# Access Compliance Report

## Public Rights-of-Way

### (Curb Ramps)

Intersection ID: 12809	Main Street: N_MCDOWELL_ST	Cross Street: E_7TH_ST	Location:	N
ADA ID: CDBD1DBD7E8B	Ramp Type: PerpDiag	Initial Pass/Fail: Fail	Overall Compliance: No	Severity Score: 22.5
Codes/Mitigation Info/Possible Solution		Field Measurements/Component Compliance

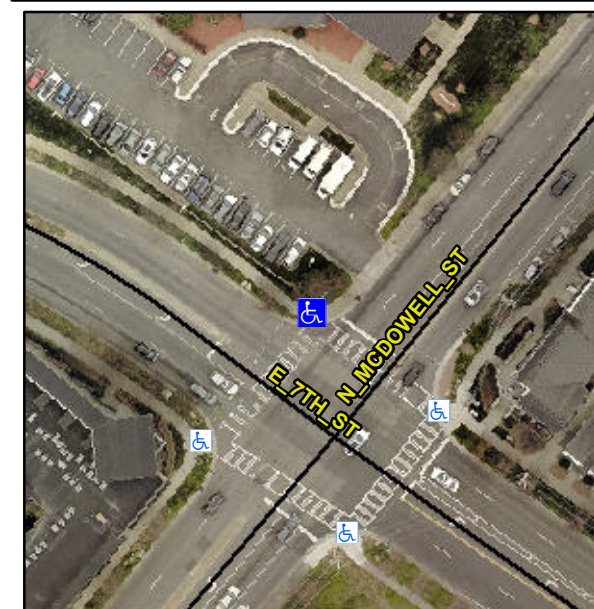
**Not Found, R304.5.1, R304.2.2, R304.5.3**

Compliance	Description	Data	Compliance	Description	Data
N/A	Ramp Length (in)	62.0	No	Ramp Slope (%)	8.6
No	Ramp Width (in)	41.0	No	Ramp XSlope (%)	2.9
N/A	Flare Type LT	N/A	N/A	Flare Type RT	N/A
N/A	Flare Slope LT (%)	N/A	N/A	Flare Slope RT (%)	N/A
N/A	Flare Traversable LT?	N/A	N/A	Flare Traversable RT?	N/A
N/A	Landing Length (in)	N/A	N/A	DWS Provided?	N/A
N/A	Landing Width (in)	N/A	N/A	DWS Contrast?	N/A
N/A	Landing Slope (%)	N/A	N/A	DWS Length (in)	N/A
N/A	Landing X Slope (%)	N/A	N/A	DWS Full Width?	N/A
N/A	Landing Curb? (Y/N)	N/A	N/A	DWS Offset (in)	N/A
N/A	Shared Landing?	N/A			
N/A	Gutter Ponding?	N/A	N/A	Gutter Slope (%)	N/A
N/A	Gutter Lip Ht (in)	N/A	N/A	Gutter X Slope (%)	N/A
N/A	Painted X Walk1?	Yes	N/A	Painted X Walk2?	Yes
	X Walk 1 Direction	To SW		X Walk 2 Direction	To SE
N/A	X Walk 1 Width (in)	112.0	N/A	X Walk 2 Width (in)	113.0
	X Walk 1 Slope (%)	0.2		X Walk 2 Slope (%)	0.1
	X Walk 1 X Slope (%)	2.9		X Walk 2 X Slope (%)	1.9

**Remove & Replace Curb Ramp With Two New Directional Ramps or Equivalent.**
